SUBJECT: Responds to 781018 request for addl info re spent fuel mod
 for subj facil.Forwards detailed description of completed
 changes.

Re: Nine Mile Point Unit 1
Docket No. 50-220
DPR-63

Responses to October 18, 1978

Nuclear Regulatory Commission Questions

FIGURE 1

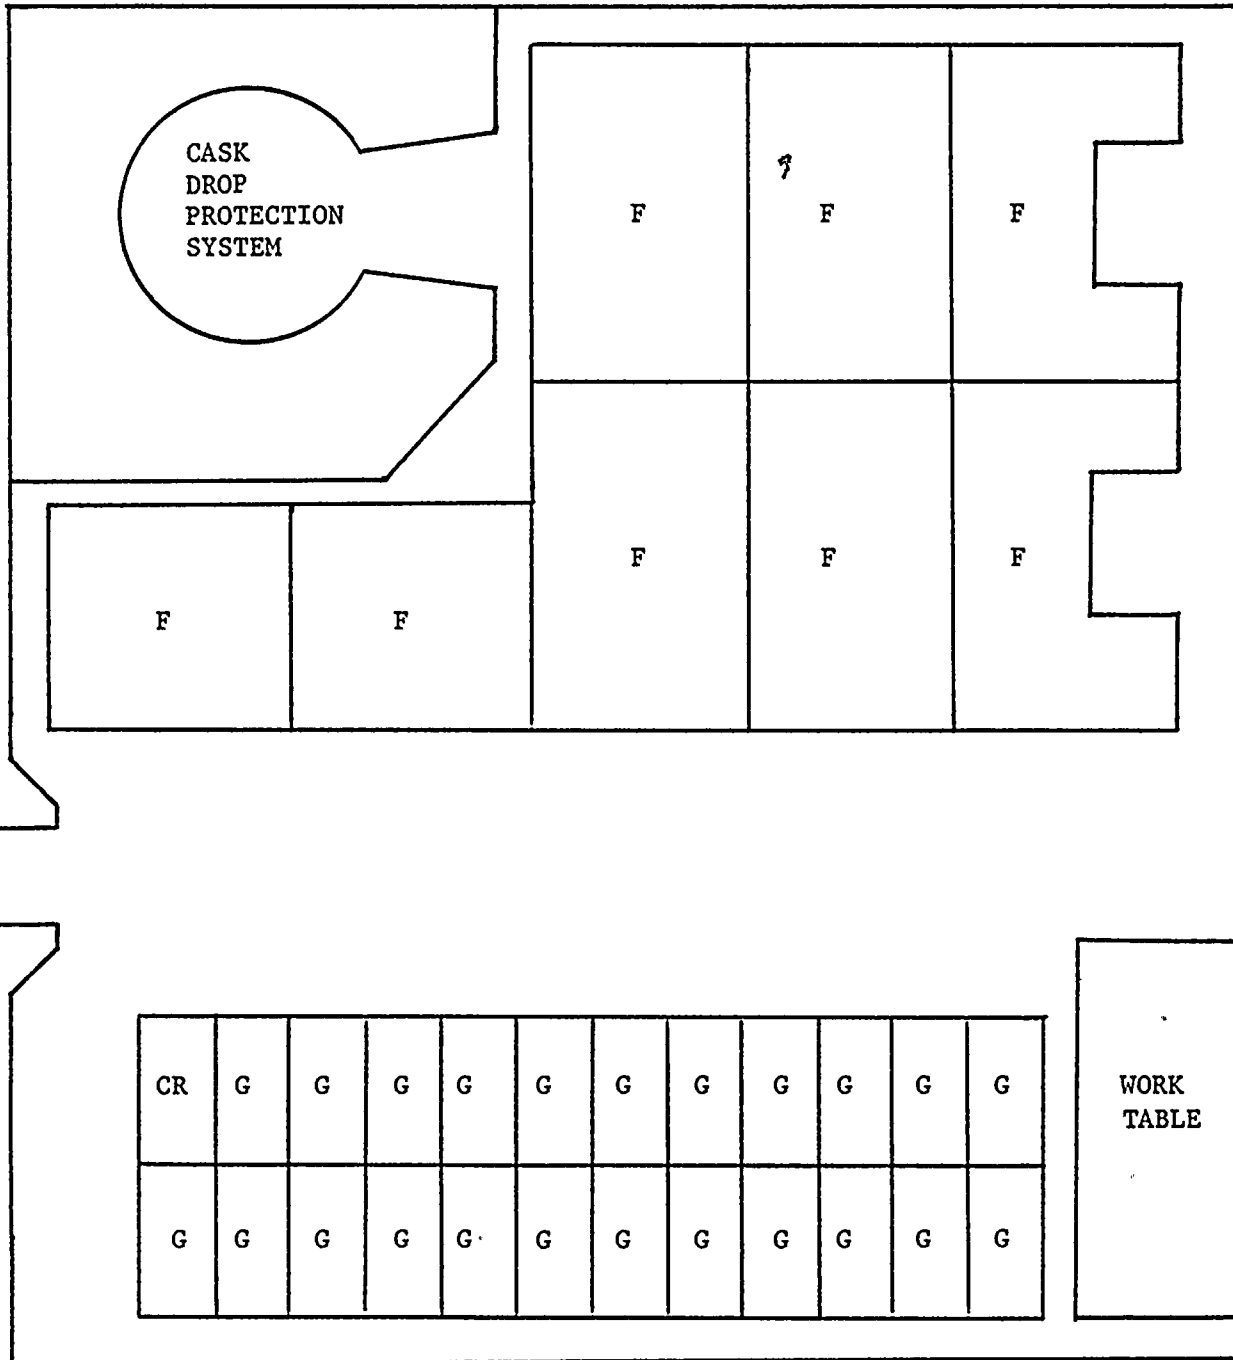
1. Question

Provide a description of the modifications that have been made to the Nine Mile Point Unit 1 (NMP-1) spent fuel pool (SFP) after the pool was licensed to contain up to 1984 fuel assemblies. Discuss the effects of these modifications on operating the SFP. This should include the measured man-rem exposure to do the work, the change in radiation levels in the vicinity of the pool, the change in the amount of crud in the pool, and changes to the operation of the SFP purification system.

Figure 1 outlines the current configuration of the spent fuel storage pool. Seventeen standard General Electric spent fuel storage racks and six channel storage racks were removed from the spent fuel pool. One control blade storage rack was relocated from the north end of the pool to the south end. Seven control blade storage racks were removed from the spent fuel pool and will eventually be relocated. Installed in the north end of the spent fuel pool were 1060 high density stainless steel spent fuel storage locations. Of the racks removed, 15 standard spent fuel storage racks and 2 channel storage racks were decontaminated, packaged and shipped off site.

FIGURE 2

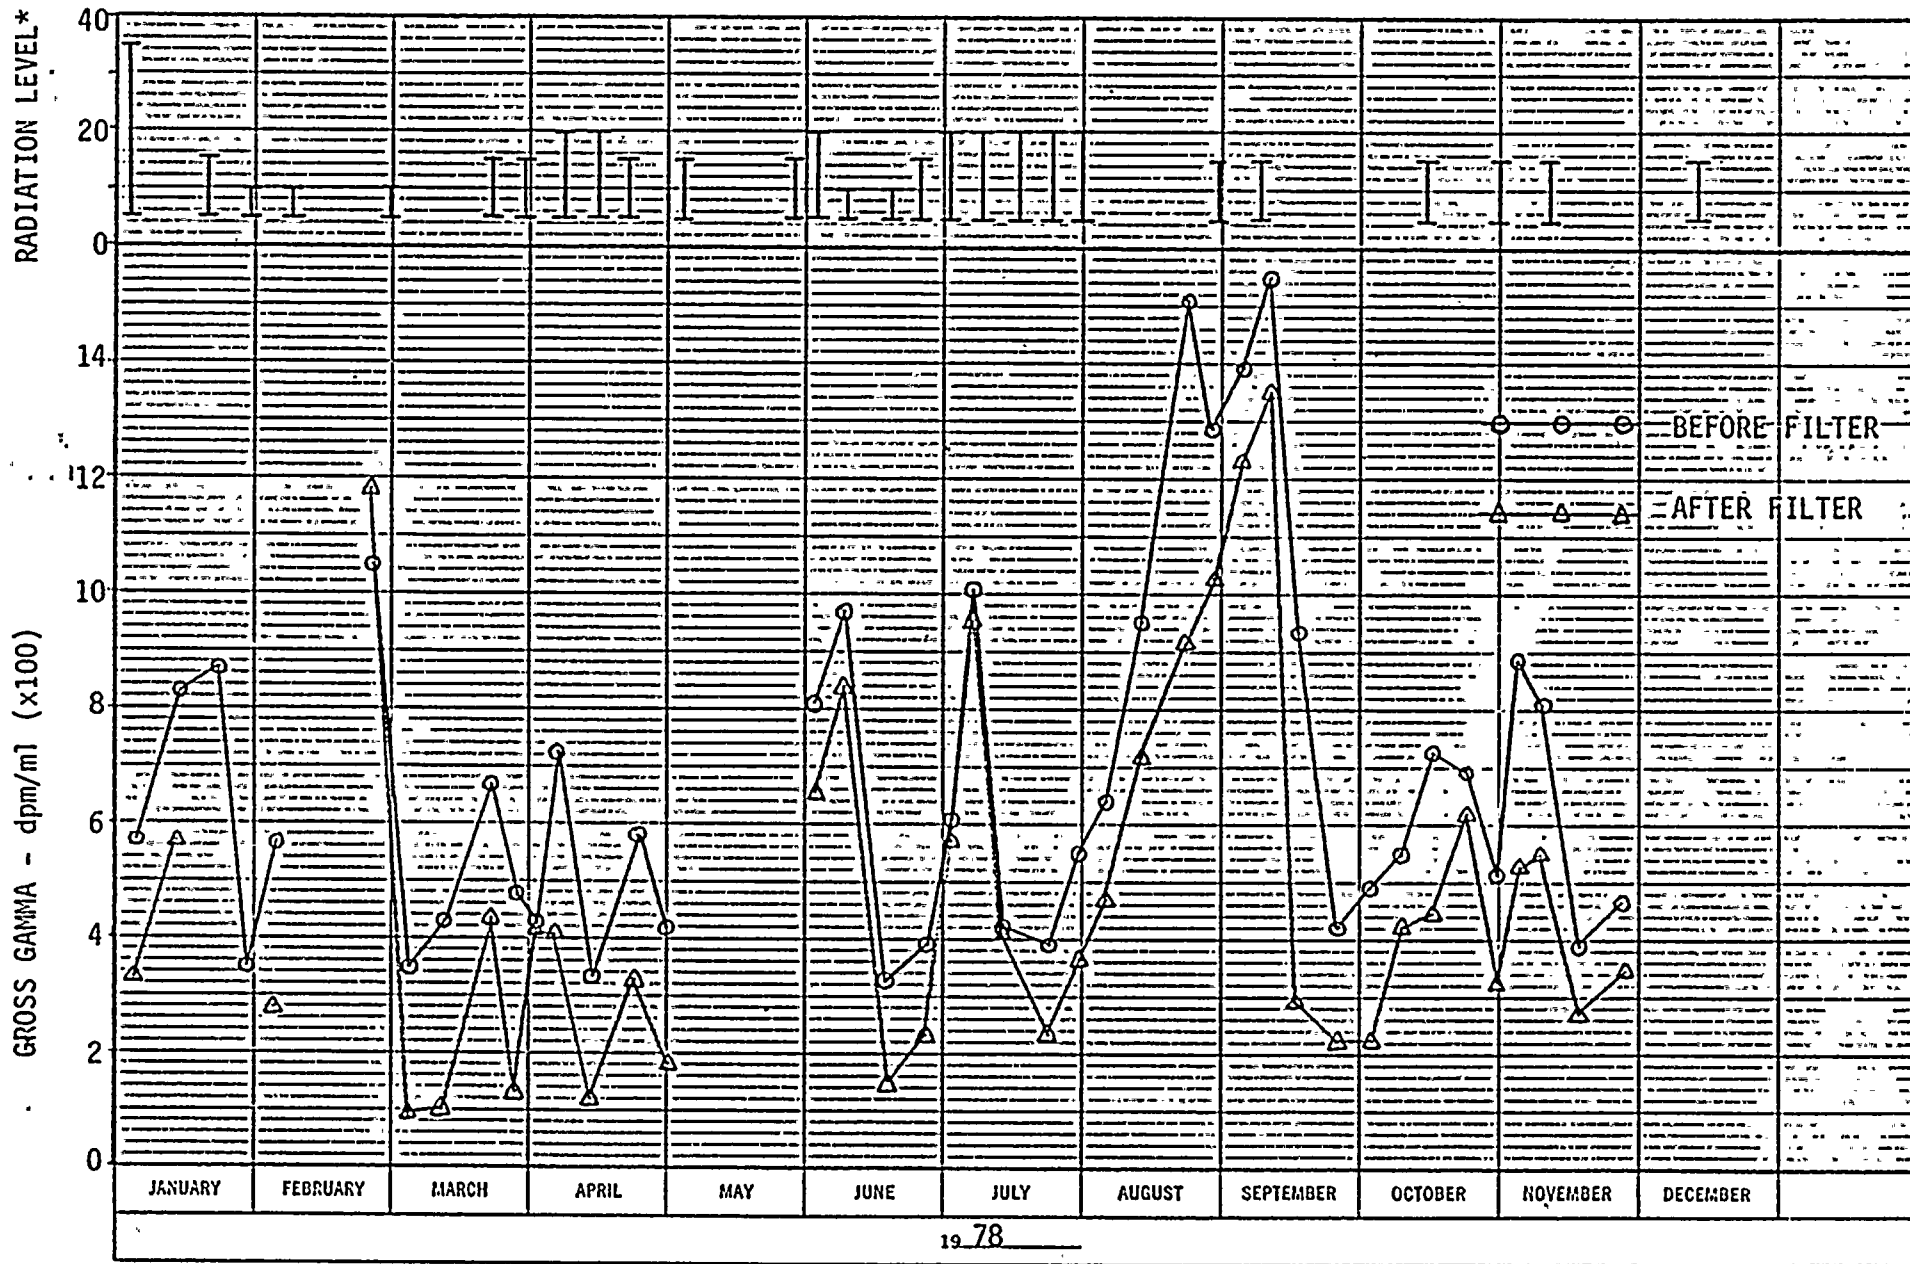
8. Question

Discuss the effect of the fuel assembly movements during your 1978 SFP modification on the amount of crud in the pool water and the radiation levels in the vicinity of the pool. Your response should include measured radioactivity concentrations of SFP water and general radiation levels in the vicinity of the pool before, during and after the 1978 SFP modification.

Figure 2 summarizes the spent fuel pool filter gross gamma count and the general radiation levels above the surface of the pool before, during and after the 1978 spent fuel pool modification. Fuel assembly movements were conducted between June 2-9 and resulted in very little increase in crud disposition. The greatest disturbance of crud was encountered during removal of the old spent fuel storage racks and during the general pool clean-up where the crud was vacuumed from the floor of the spent fuel pool. During the modification, due to the pool cleanup, the total volume of crud in the spent fuel pool was decreased.
